# Submissions Report

## Stage 2 – Stations, Rail Infrastructure and Systems

Incorporating Preferred Infrastructure Report

MARCH 2013

Figure 2.1 Bella Vista Station access from Glenwood – existing and proposed

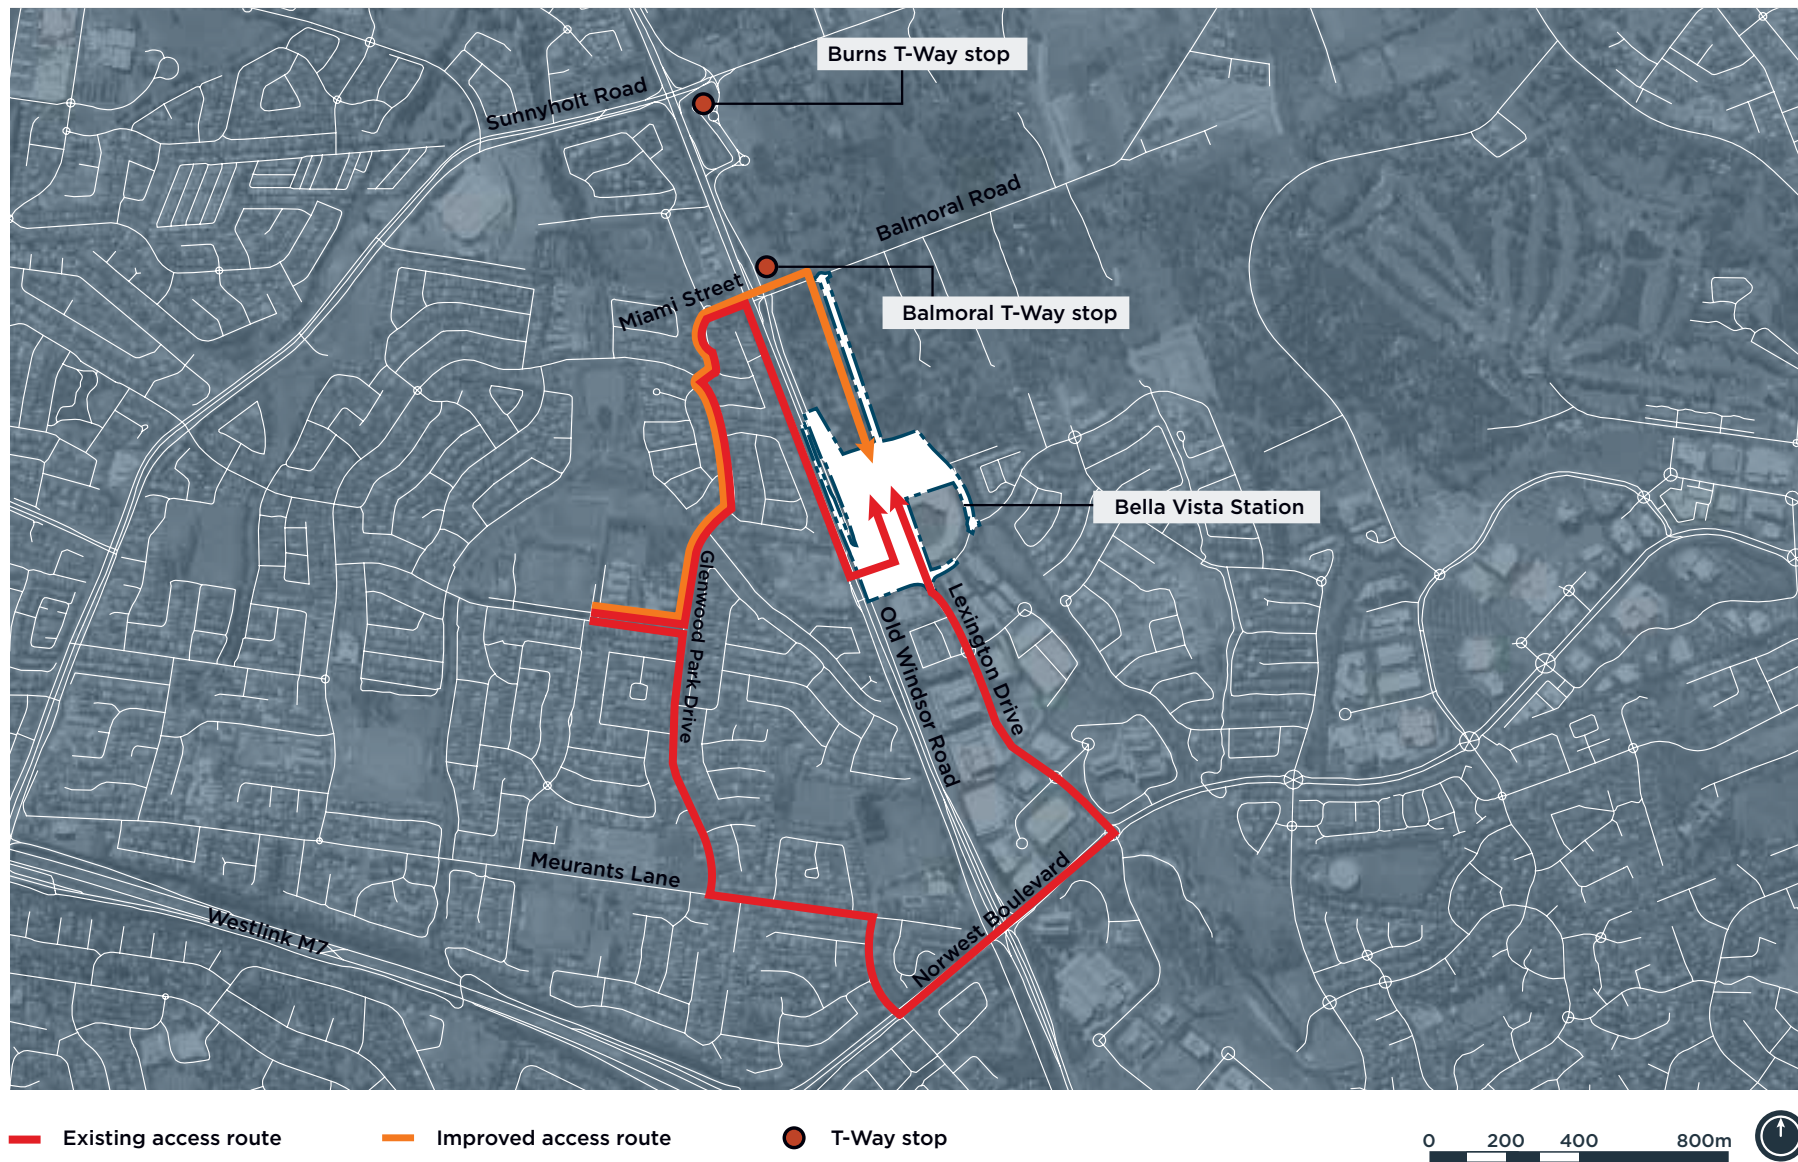
In response to ongoing design refinements and feedback received from Deliberative Research Forums, and in consultation with Roads and Maritime Services (RMS), improvements to the wider road network have been identified to better manage traffic and improve Bella Vista Station access over time.

Figure 2.2 Bella Vista Station access from Glenwood with the proposed intersection arrangement

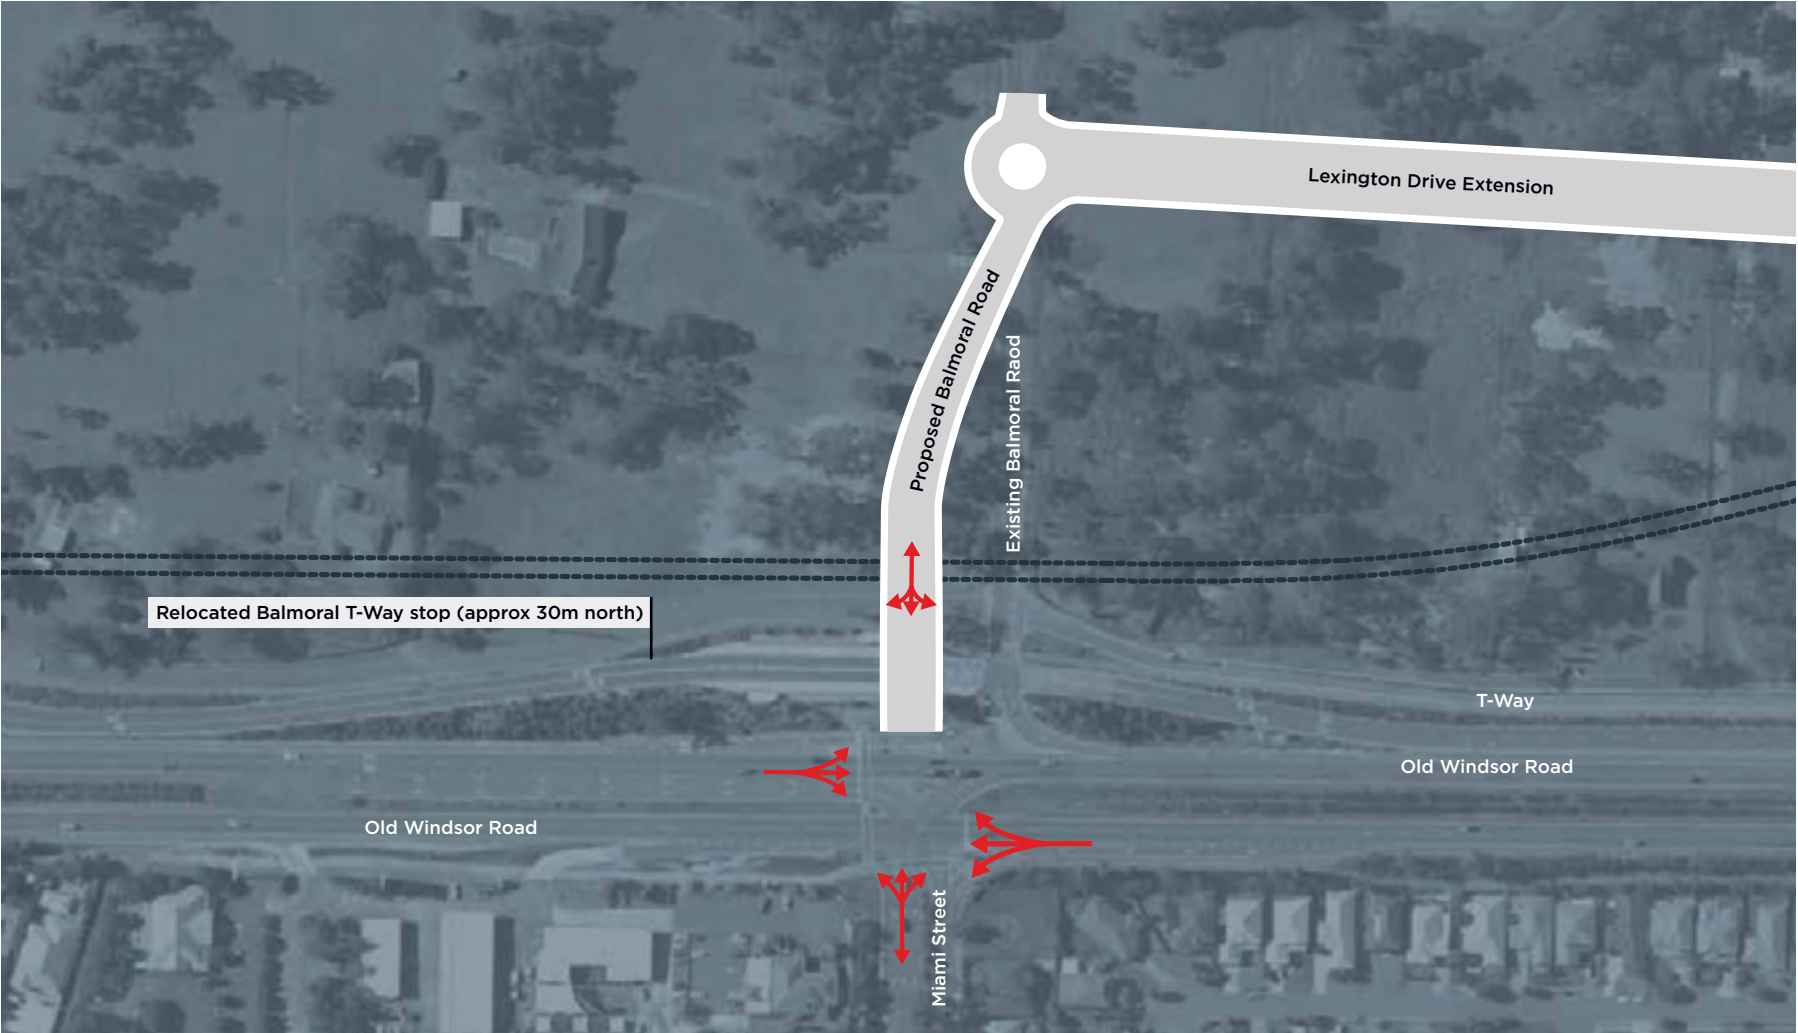
The proposed arrangement at the Old Windsor Road / Balmoral Road / Miami Street intersection consists of realigning Balmoral Road approximately 30 metres to the north to provide a direct connection to Miami Street. The proposed intersection arrangement is illustrated in **Figure 2.2**.

The existing Balmoral T-Way stop would be relocated approximately 30 metres to the north. The location of the proposed Balmoral Road overbridge across the rail cutting would be moved slightly further north and its width would be increased to provide for two traffic lanes in each direction and pedestrian footpaths on each side of Balmoral Road.
